<p align="center">SUSPENSION MODIFICATION SERVICE BULLETIN</p>	<p align="center">UP 105 REV 3 2014-10-06</p>
		<p align="center">Page 1 of 1</p>

AMBULANCE TYPE: MX151D (63100 - 63149)

SUSPENSION MODIFICATION (BC)

DRAWING : # 00904

SUSPENSION MODIFICATION (BC)

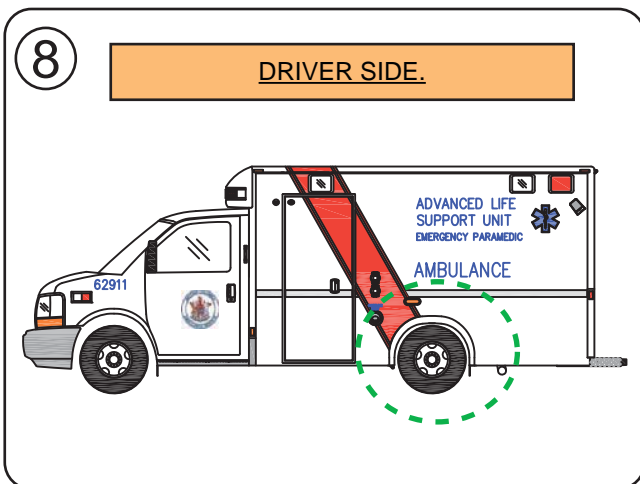
Remove spring center bolt (through bolt) with clamps installed (note: may require vice grips on bottom to hold through bolt while removing upper 15mm nut on through bolt).

Add new lower spring to leaf pack.

Enlarge hole on top plate to allow for clearance of nut.
Enlarge to 3/4" using bit.

Install new center bolt into spring pack.
Tighten nut properly and cut excess of bolt with die grinder.

Reinstall spring pack in vehicle with new u-bolts, top plate and nuts as per workshop manual.
